Dam Safety Assessment of CCW Impoundments

WH Zimmer Station

United States Environmental Protection Agency
Washington, DC

June 2010

FIGURE 3

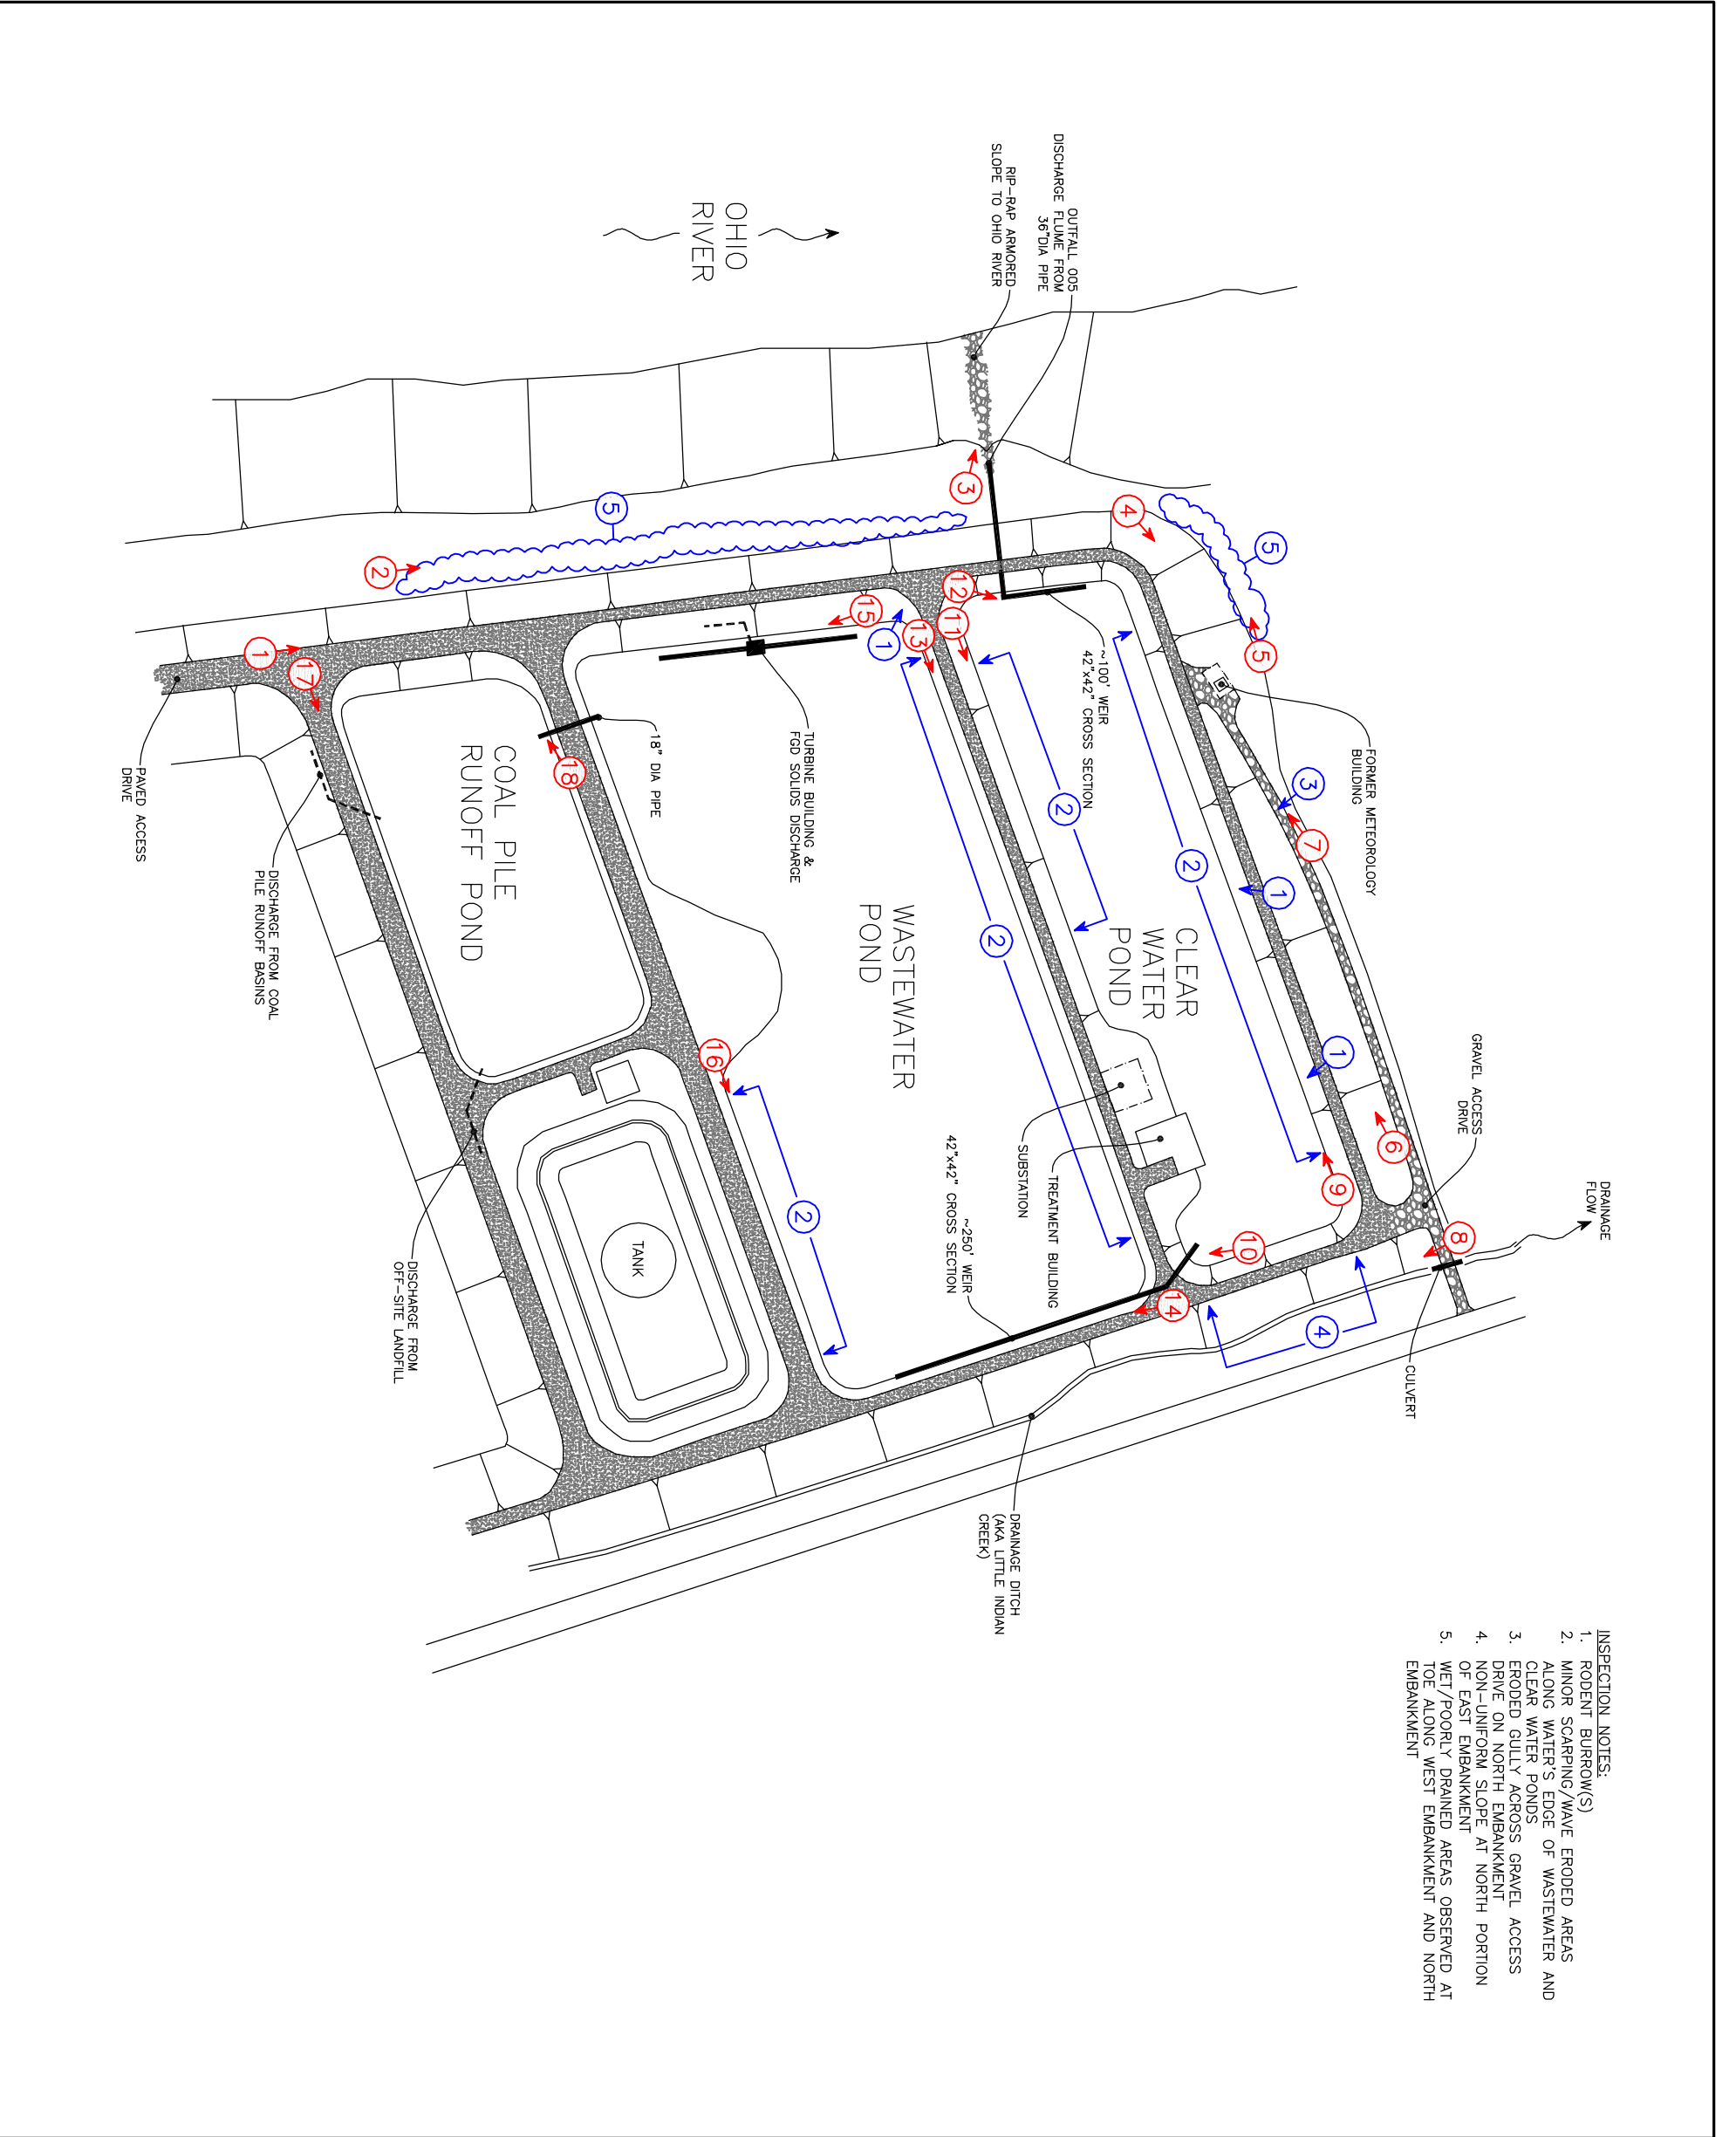
- INSPECTION NOTES:**
1. RODENT BURROW(S)
 2. MINOR SCARPING/WAVE ERODED AREAS ALONG WATER'S EDGE OF WASTEWATER AND CLEAR WATER PONDS
 3. ERODED GULLY ACROSS GRAVEL ACCESS DRIVE ON NORTH EMBANKMENT
 4. NON-UNIFORM SLOPE AT NORTH PORTION OF EAST EMBANKMENT
 5. WET/POORLY DRAINED AREAS OBSERVED AT TOE ALONG WEST EMBANKMENT AND NORTH EMBANKMENT

INSPECTION NOTES
Date: 4/28/10
WH Zimmer Station, Moscow, OH

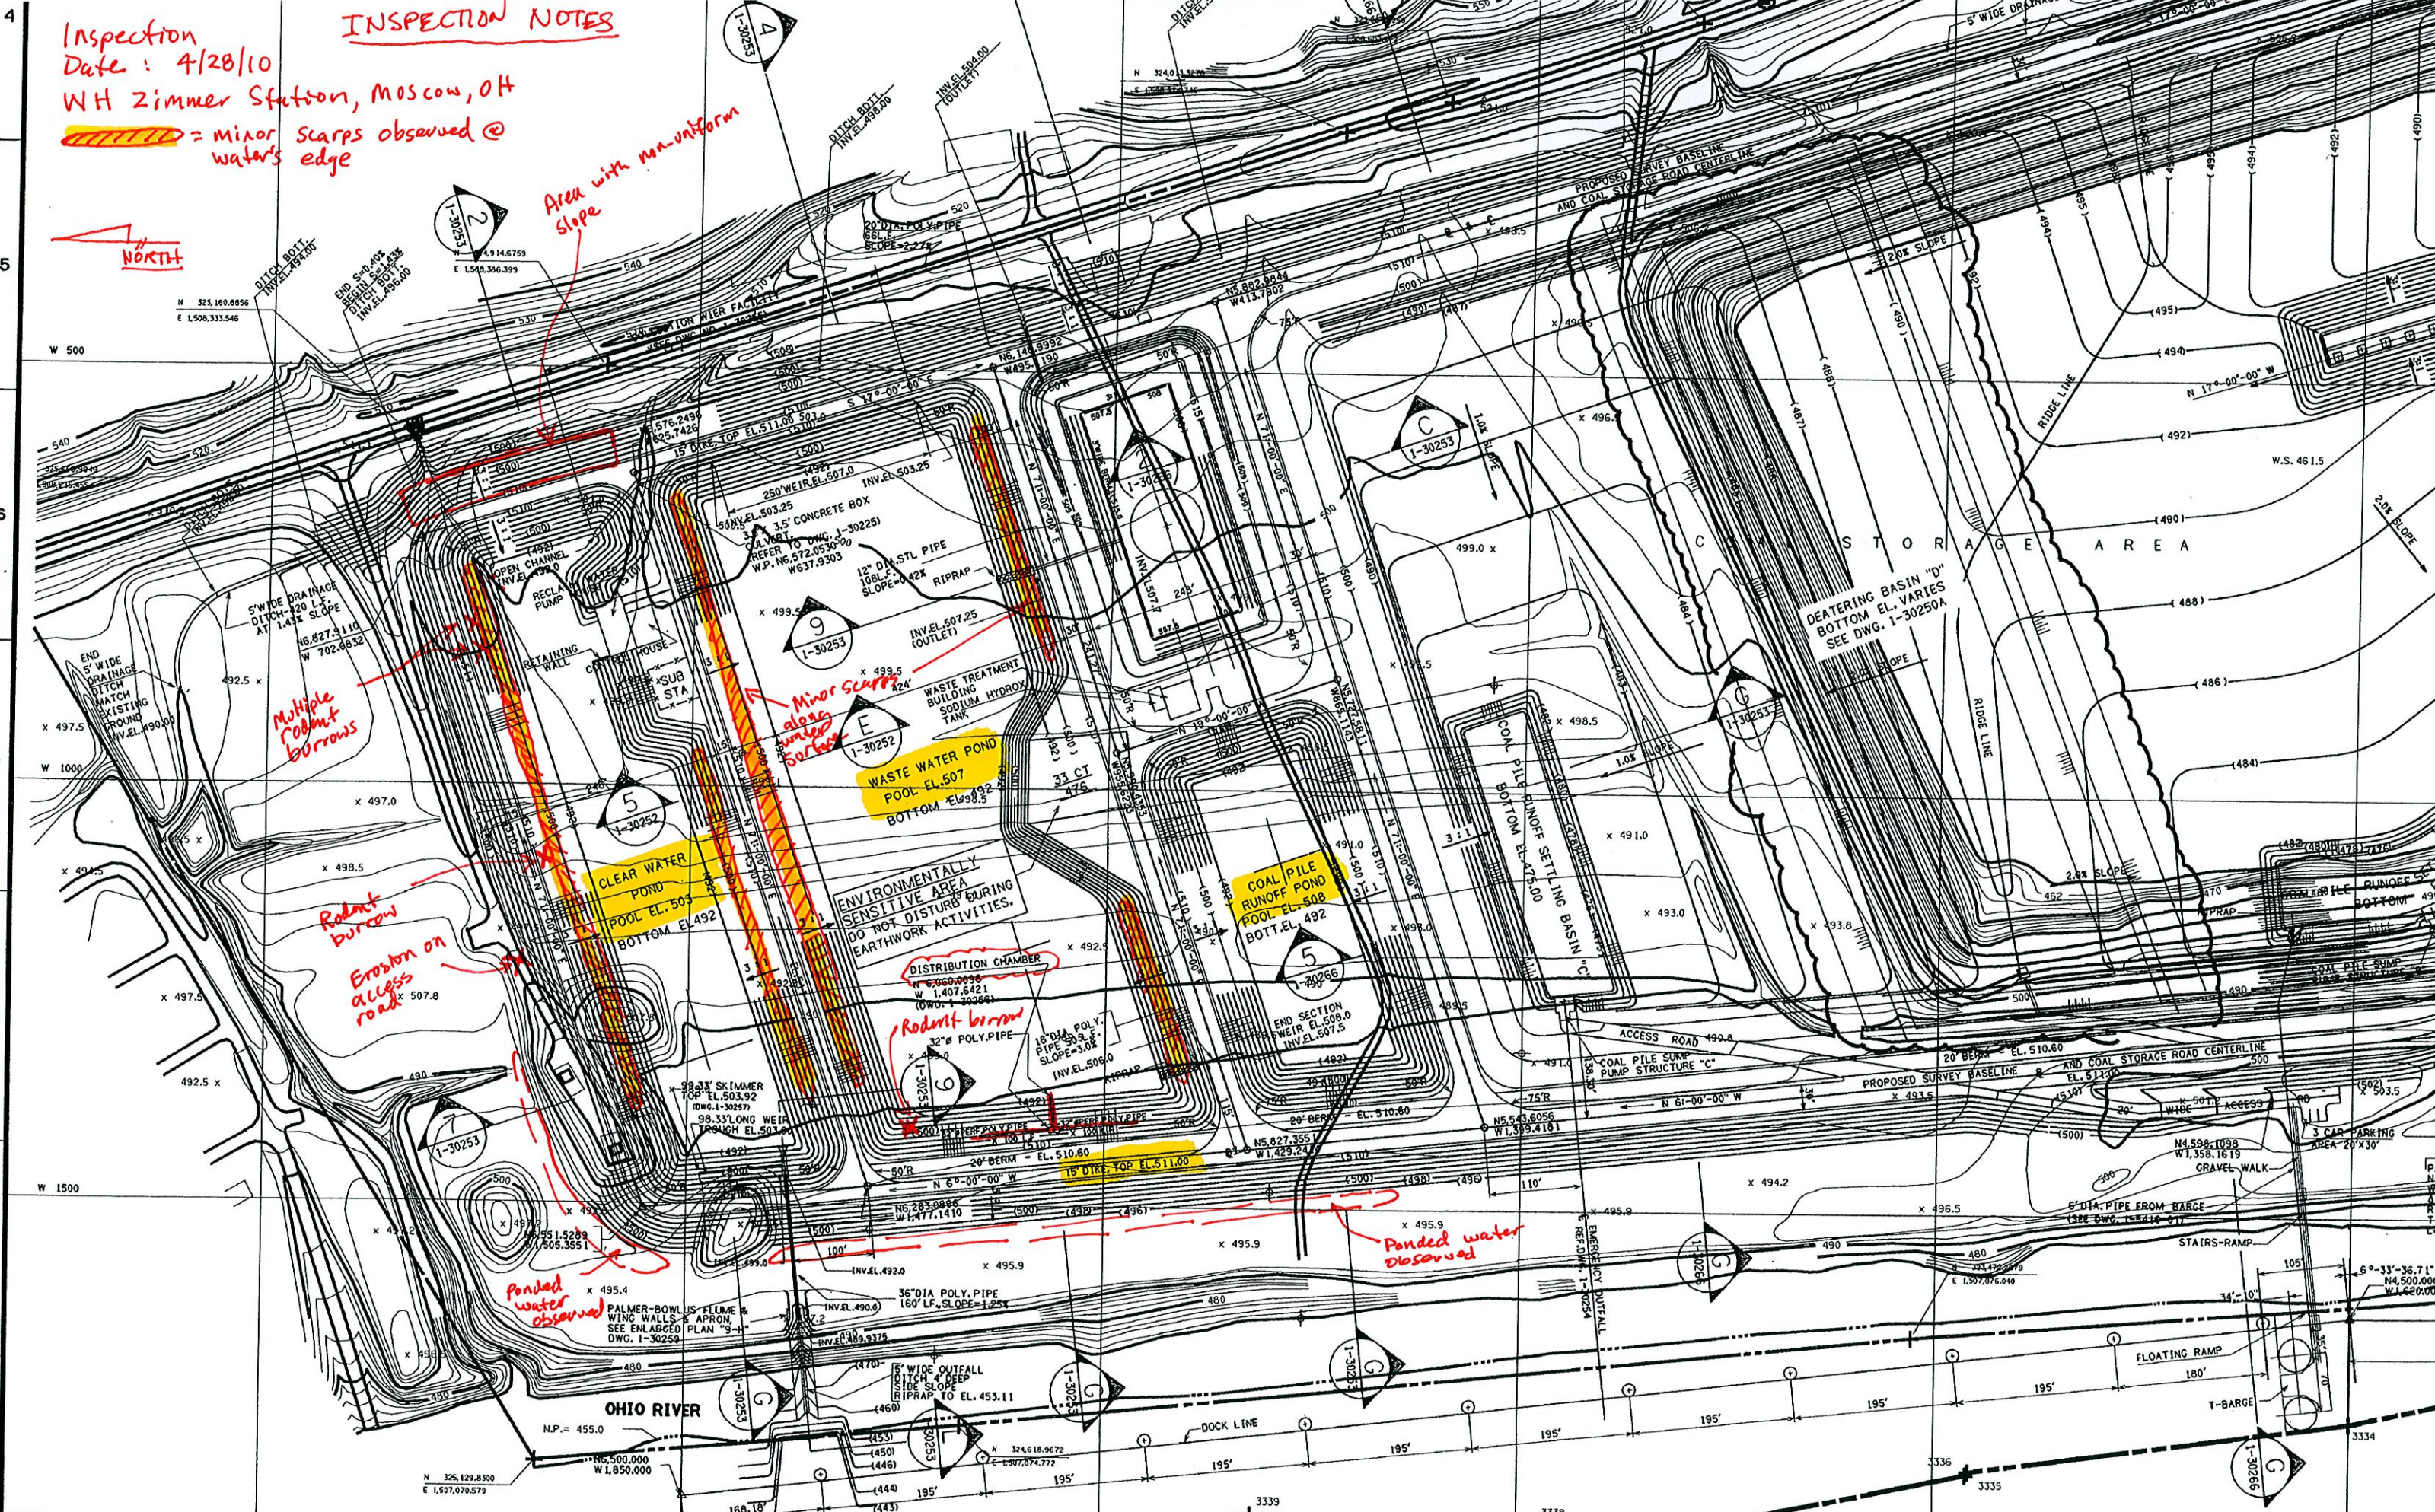
= minor scarps observed @ water's edge

Area with non-uniform slope

Multiple rodent burrows

Rodent burrow
Erosion on access road

Ponded water observed

Minor scarps along water surface

Ponded water observed
